Committee Scheme - Building 08 Ground Floor Plan

Proposed Scheme - Building 08 Ground Floor Plan

2.5 Building 10

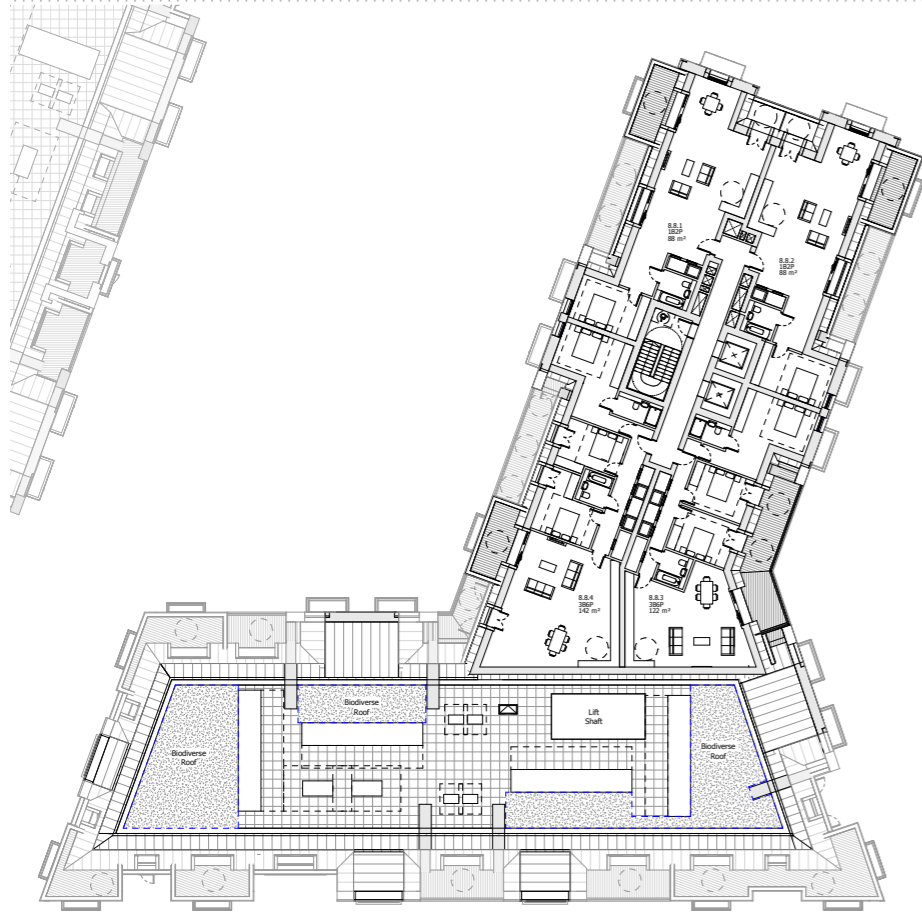
Similarly to the previous buildings the refuse store and basement entrance which were around the northern core in the committee scheme have been removed, with the residential refuse store placed in the basement. However the refuse store by the southern core has been increased. This store is a collection store which serves multiple buildings, it will be used by management to collect all of the bins from multiple building on refuse collection days. More detail on the refuse strategy can be found in the Operational Waste Management Plan

Proposed Scheme - Building 08 Eighth Floor Plan

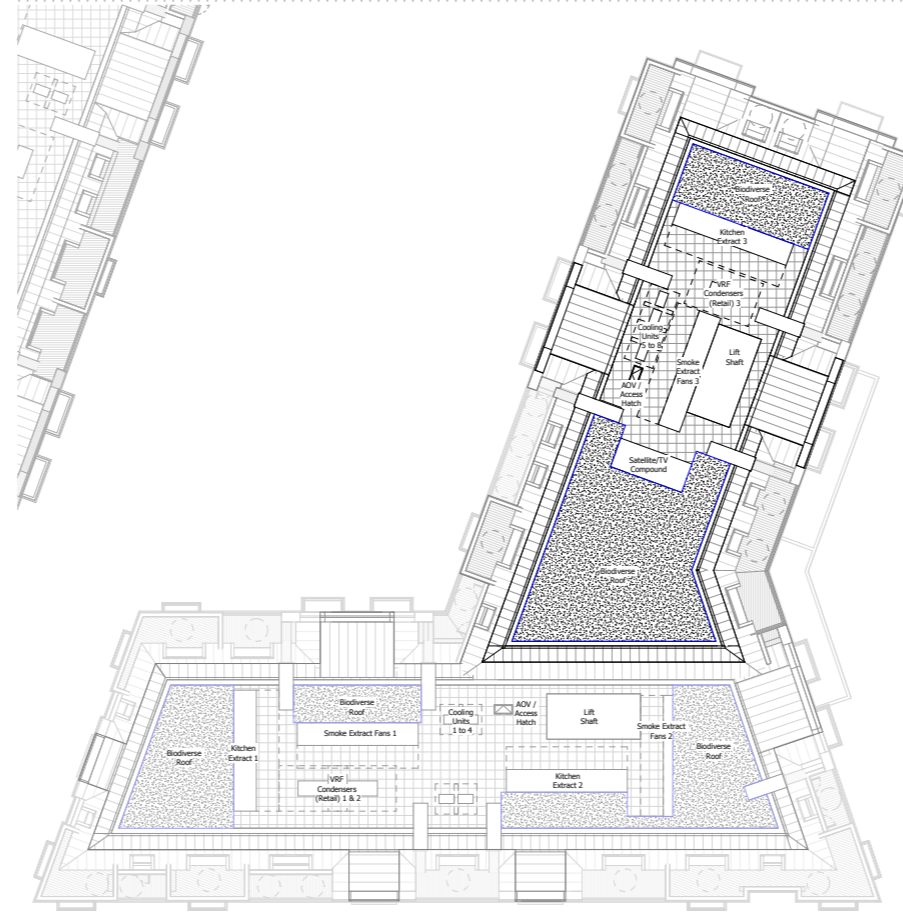
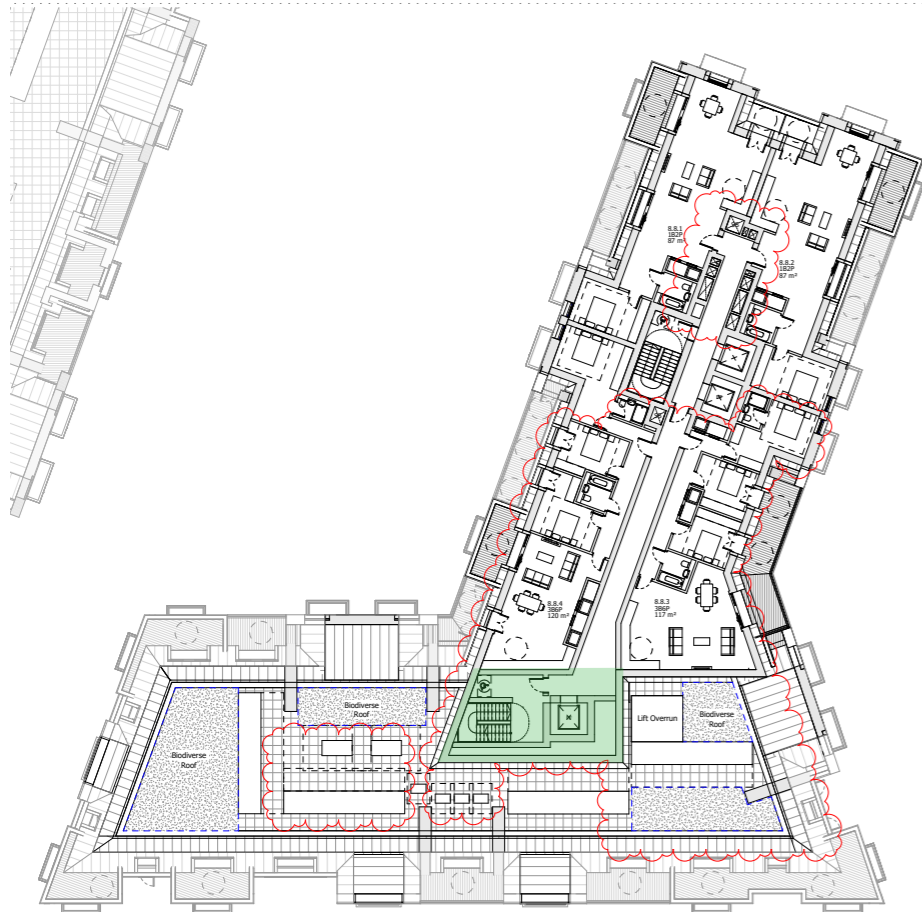
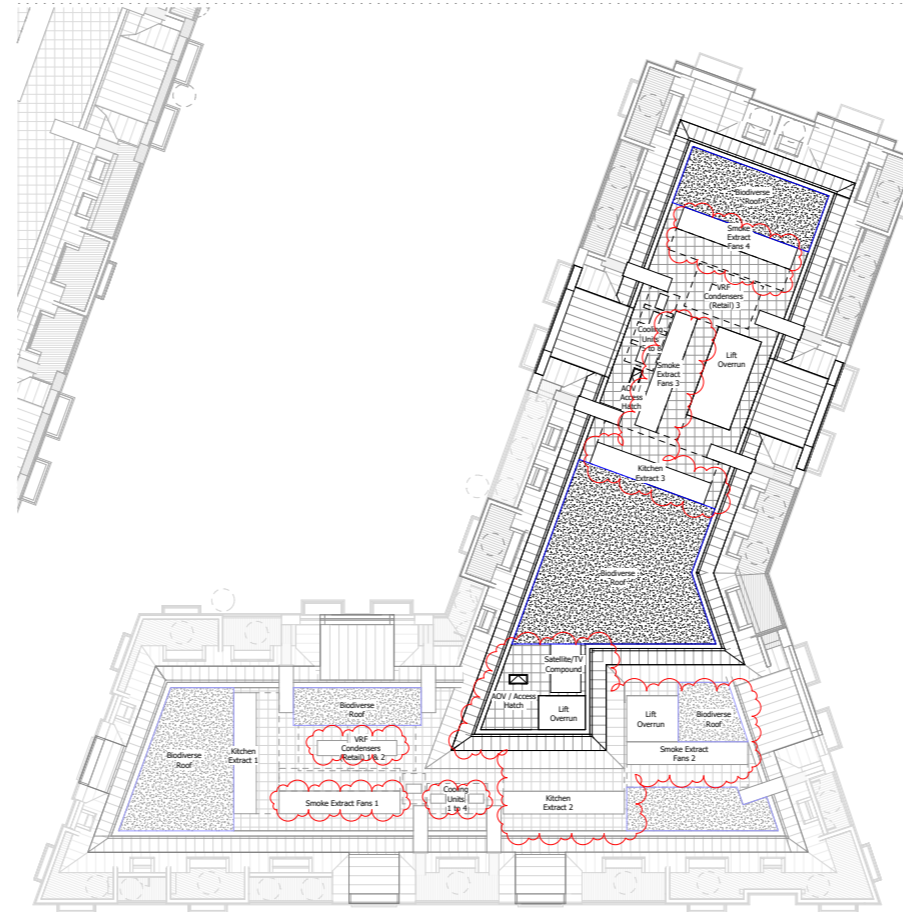
Building 08 differs from the buildings previously discussed in this document as the top floor, the 8th floor, only extends across half of the building with one of the cores previously stopping at the floor below. Both staircases and fire fighting shafts in the building now need to extend to the top occupied floor therefore the footprint of the 8th floor has had to increase to the south to accommodate the other core. See increased area shown in green. This extension is still set far back from the southern, eastern and western facades so although the change can be seen from ground level at some angles, the impact is minimal and has not changed the design intent of the stepped building form. Please see the comparative illustrative images in the appendix of this document to see the extent of this change.

Proposed Scheme - Building 10 South Elevation

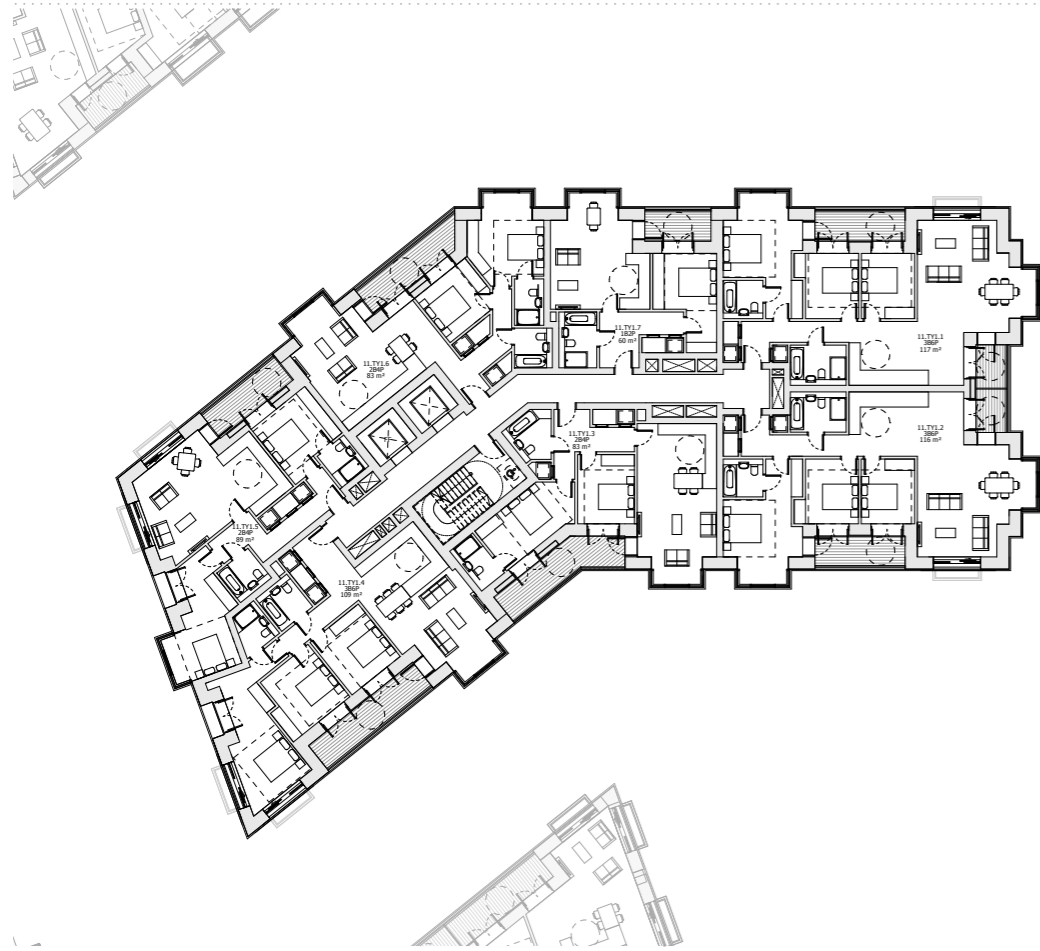
- 1.1 The top occupied floor of Building 10 in the committee scheme was 18.13m above ground level. Given the narrow depth of floor plan and east/west orientation of the block it would not be possible to add additional staircases to this building without significantly compromising the apartments. Therefore the decision has been taken to reduce the floor to ceiling height of the typical residential floors by 50mm each to bring the building under 18m, therefore not requiring changes to the plan.

Proposed Scheme - Building 11 Typical Floor Plan

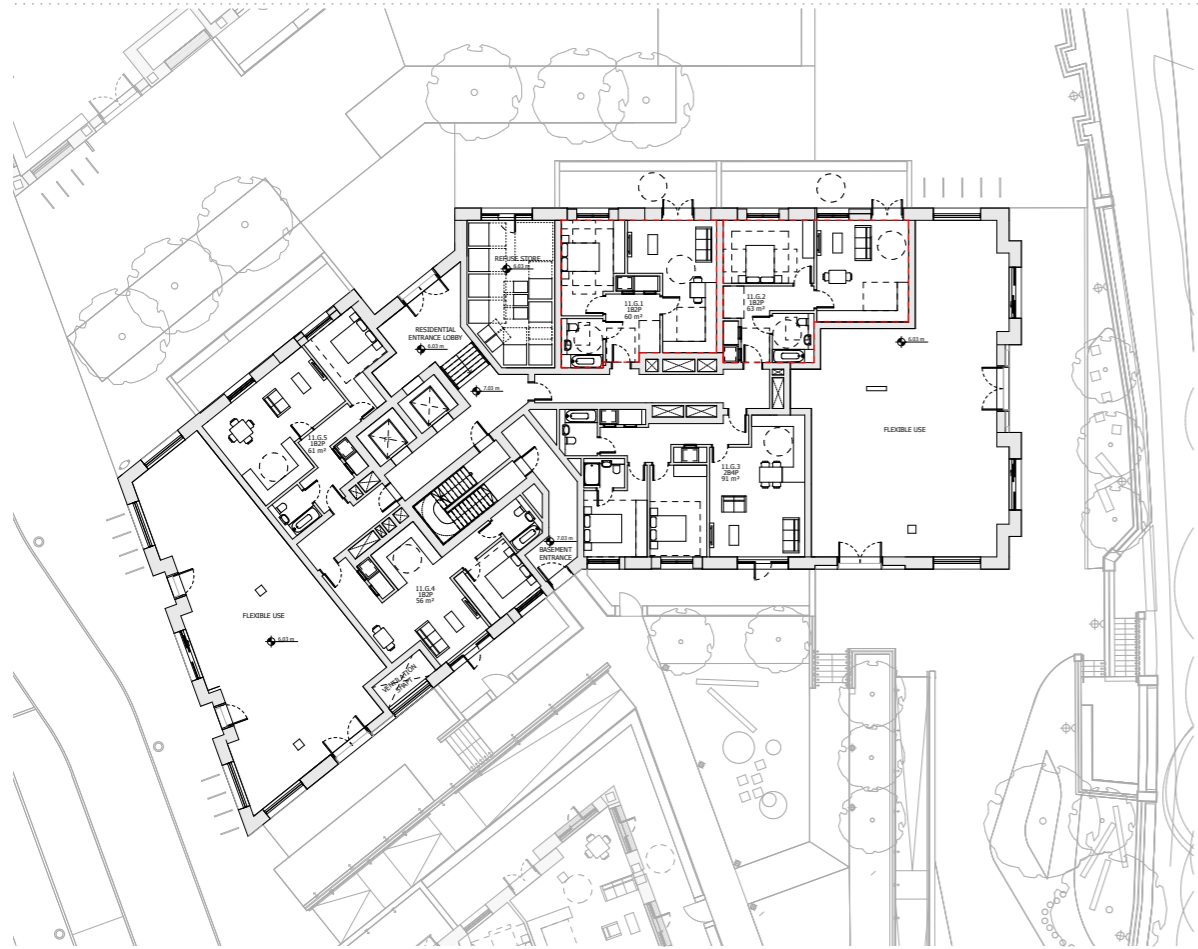
In the committee scheme Building 11 only had one core with one staircase and two lifts. Therefore, as this building is over 18m, an additional staircase is required to meet emerging fire regulations. This has been placed at the end of the corridor away from the existing staircase (see new staircase highlighted in red). This additional staircase also requires fire fighting lift in close proximity so these proposals have introduced a 3rd lift (also highlighted in red).

These changes have not impacted the number of units or habitable rooms in this block.

Proposed Scheme - Building 11 Ground Floor Plan

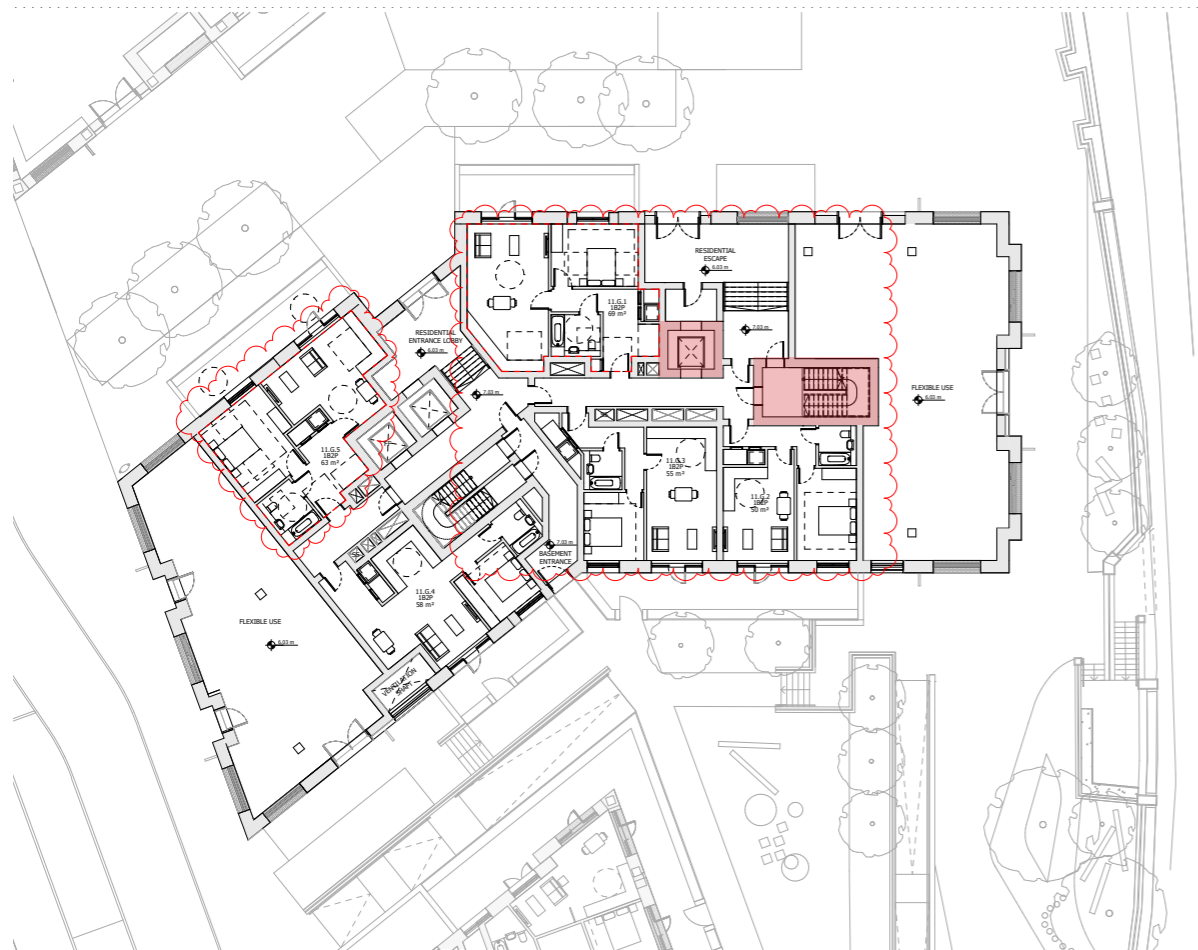
A separate entrance at ground floor level has been introduced to the new stair and lift. This, and moving the refuse store to the basement, has impacted the residential unit layouts on this level including the wheelchair accessible units, however the same number have been provided.

Proposed Scheme - Building 12 Typical Floor Plan

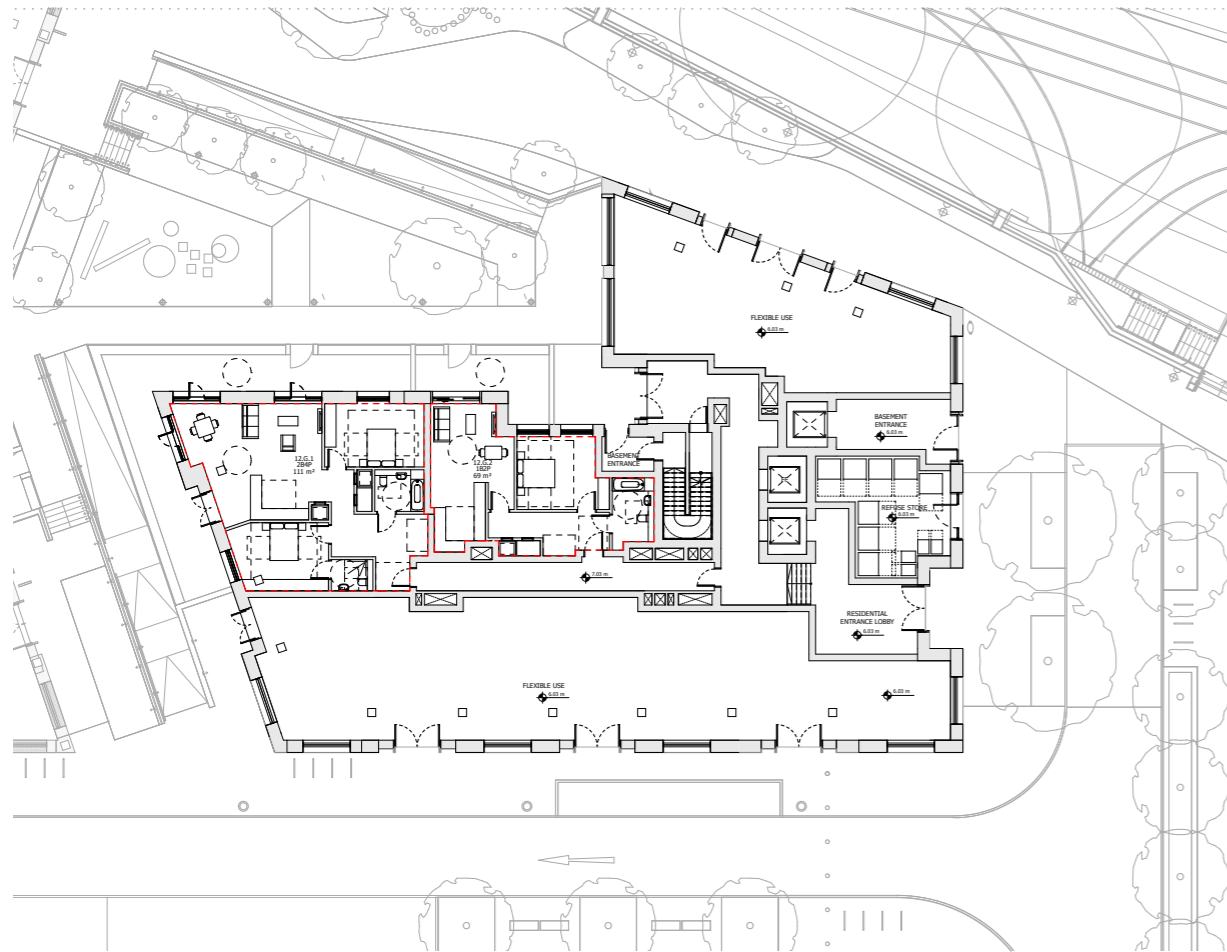
Similarly to Building 11, an additional staircase and lift have been added to Building 12 to meet the emerging fire regulations. This has led to the loss of 9 habitable rooms, but no units, in this building. The original lifts have also been moved slightly to accommodate the refuse store at ground which has resulted in changes to the residential layouts.

Proposed Scheme - Building 12 Ground Floor Plan

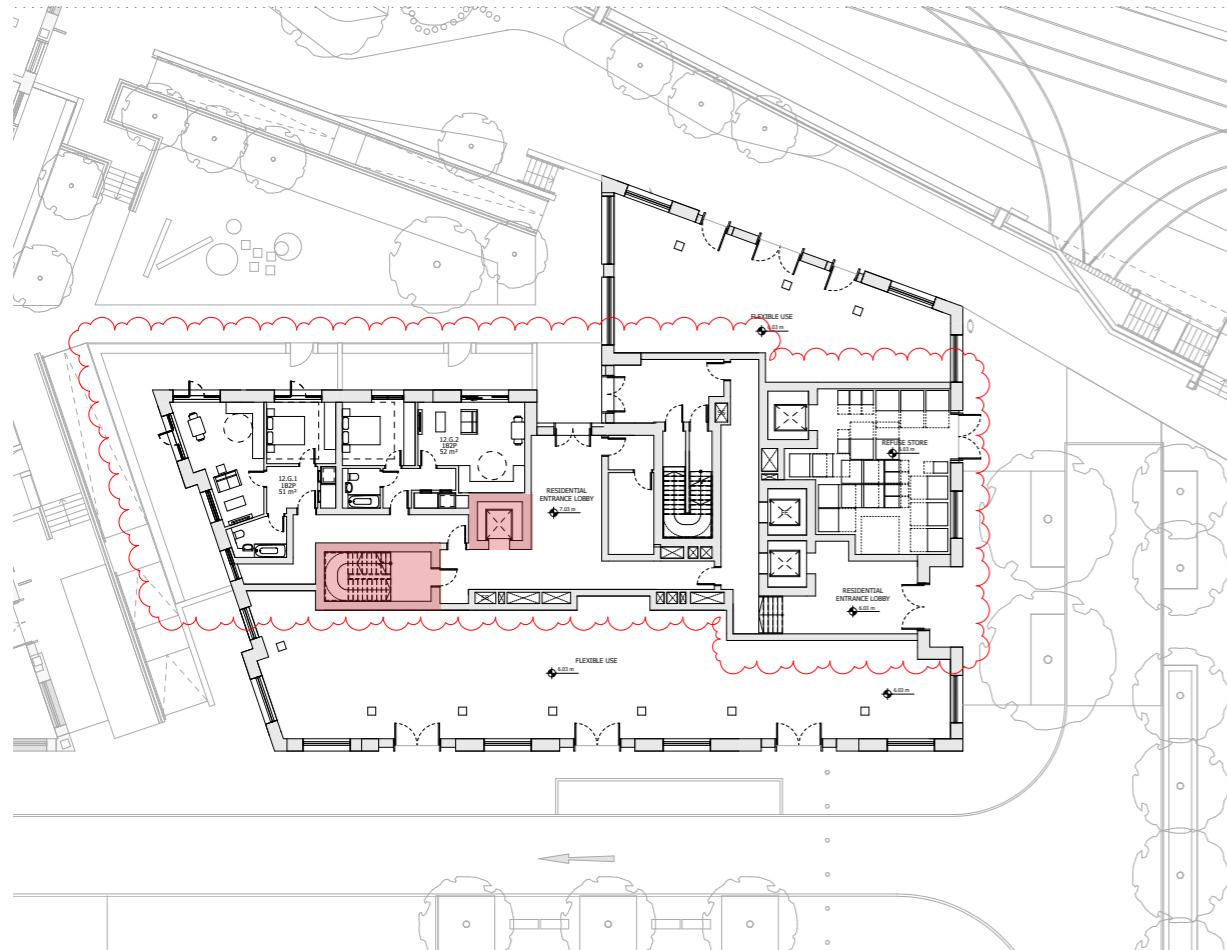
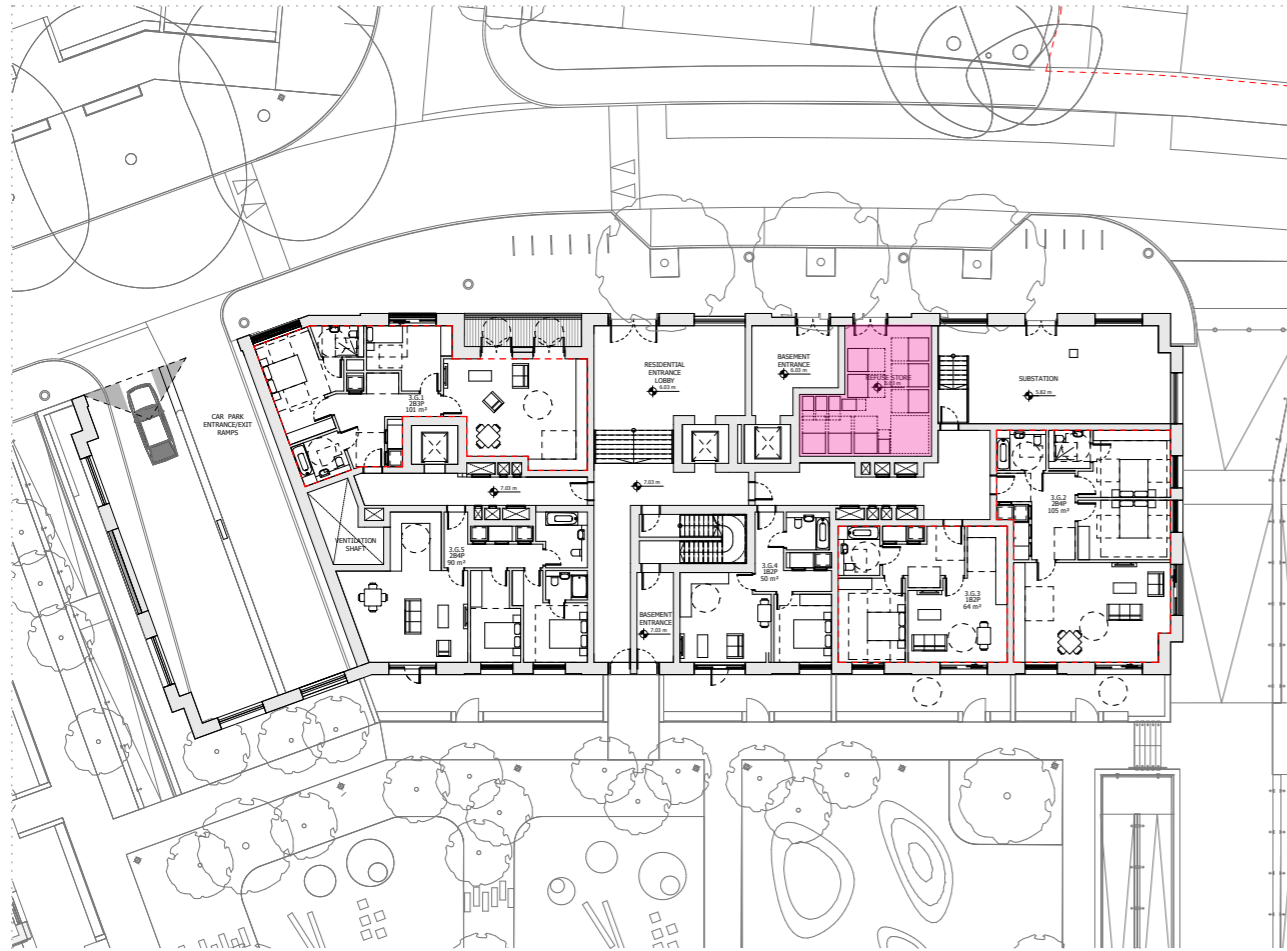
Building 12 now contains a refuse collection store as per the updated waste strategy and the lifts have been extended down to the basement, resulting in the separate basement entrance shown in the committee scheme being removed.

The wheelchair accessible units which were proposed at ground floor have been replaced by typical units due to the core changes. The accessible units have been re-provided on the typical floors.
